Waste Control Specialists LLC's Consolidated Interim Spent Fuel Storage Facility Project

Interim Storage Partners Consolidated Interim Storage Facility Project

Comments on ISP/WCS DEIS
By
Marvin Resnikoff, Ph.D.¹
Radioactive Waste Management
October 2020

Comments on CIS DEIS
By
Marvin Resnikoff, Ph.D.¹
Radioactive Waste Management Associates
September 2020

Cask Seals Degrade in Hydrocarbon fire

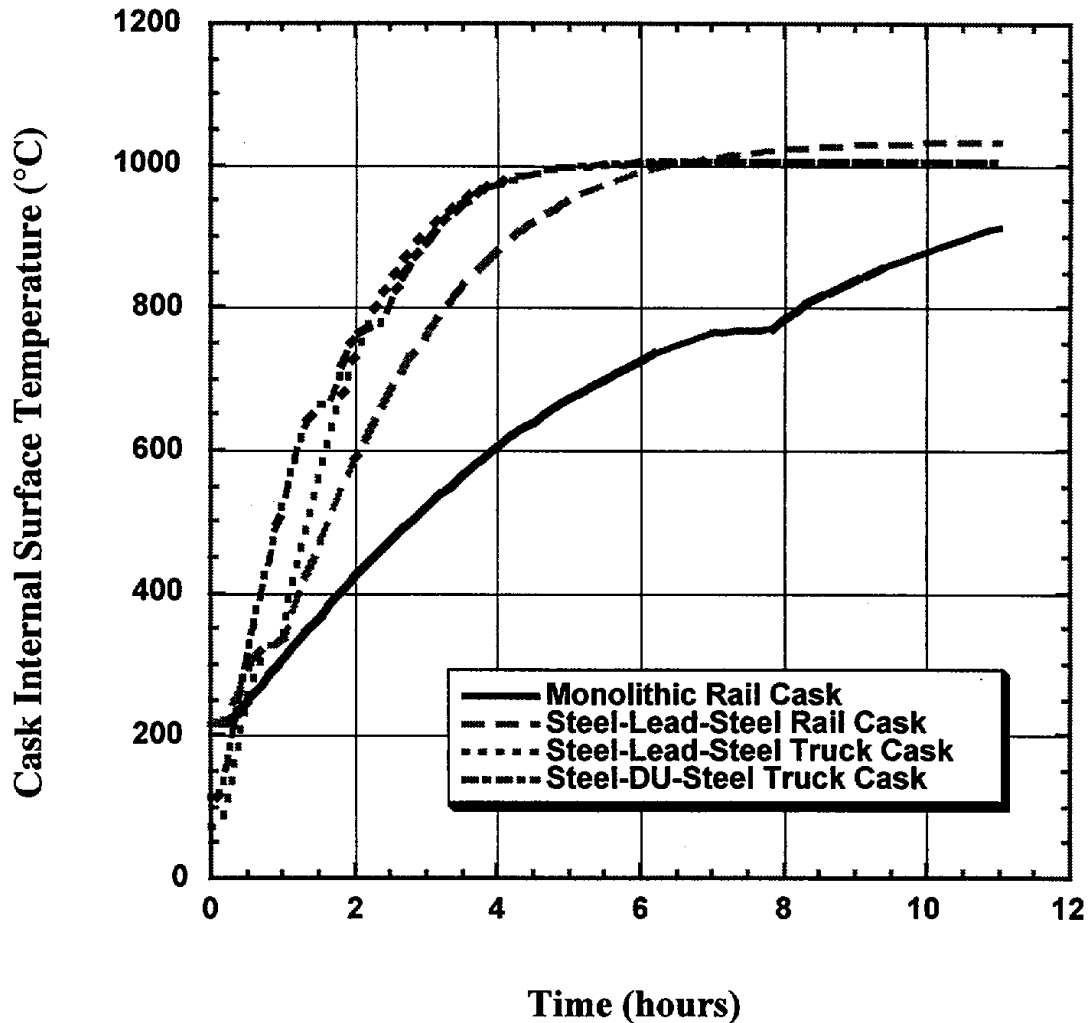
We are most concerned about fire accidents. Supporting documents to NUREG-2125 model a cask sitting on a pool of fire, a configuration that is not the most serious. NRC regulations require the cask to be at a 1 meter height above a fire pool which implies higher flame temperatures at the ends and sides of a cask. Higher flame temperatures at the cask ends can degrade the cask seals, as shown in studies by Sandia³.

As the figure from NUREG/CR-6672⁴ below shows, the monolithic steel rail cask reaches an internal temperature of 900 degrees centigrade at hour 11 of a theoretical fire. This is due to a hydrocarbon fire temperature of 1000 degrees centigrade for 11 hours. The model that is used by Sandia is a one dimensional model (radius R), so the model does not reflect the temperature at the ends of a cask nor the flame temperature for a cask 1 meter above a pool fire (which is the regulatory requirement). As Greiner shows, for a cask 1 meter above the fire pool, the temperature at the cask ends exceeds the temperature at which the seals degrade in a time that's closer to 2 hours, as discussed in the attached report. The fire temperature at the cask ends is higher than below or above the cask body. Greiner's results, which appear in a Sandia report, are based on modeling with the program CAFÉ that has been benchmarked for real fires. At the point when the seals degrade, the radioactive gases and volatiles may begin to be released from the cask that is under pressure.

Figure 1. Rail Fires, Yrs 2000 – 2009.

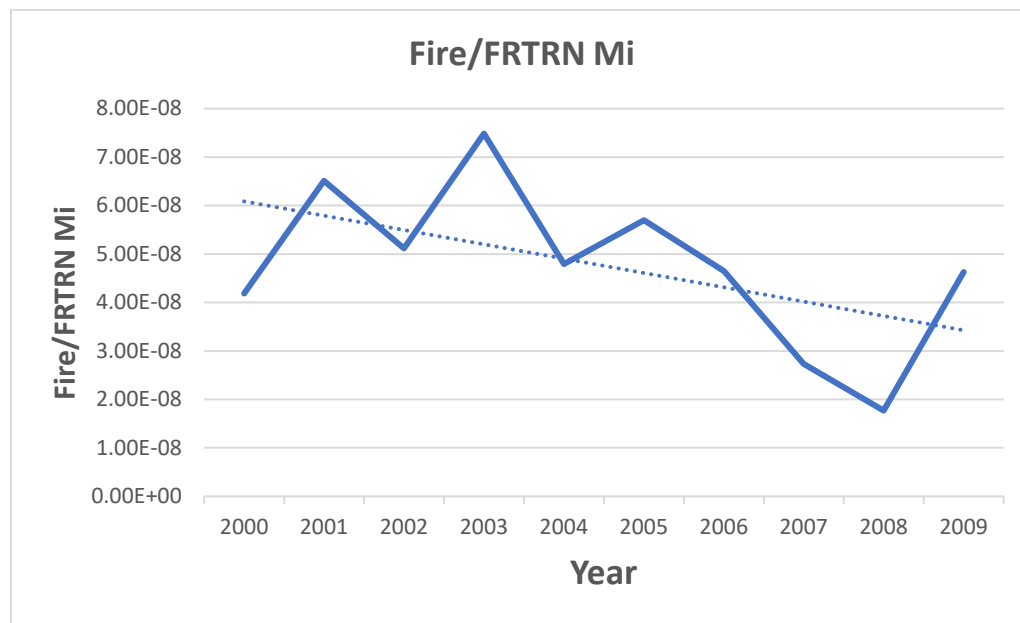
While the rail accident rate, according to FRA, has declined in the years between 2010 and 2018, the same is not true for the fire accident rate, which has risen over the same years. Our review of the FRA data show 392 accidents involving fire of varying severity between the years 2010 through 2018, ranging between 16 and 79 fire accidents per year. Comparing the periods 2000 to 2009 considered in NUREG-2125, and the period 2010 to 2018, the fire accident rate has almost doubled. NRC staff should consider the most recent data. Graphs showing rail fires per freight train mile for the years 2000 – 2009, and years 2010 – 2018 appear as Fig. 1 and 2, respectively. The reason for this increase of fire accidents is not difficult to understand; more tanker cars are on the rail, mainly from North Dakota to refineries on both coasts.

The bottom line is more fires have been occurring per accident than is acknowledged by NUREG-2125.
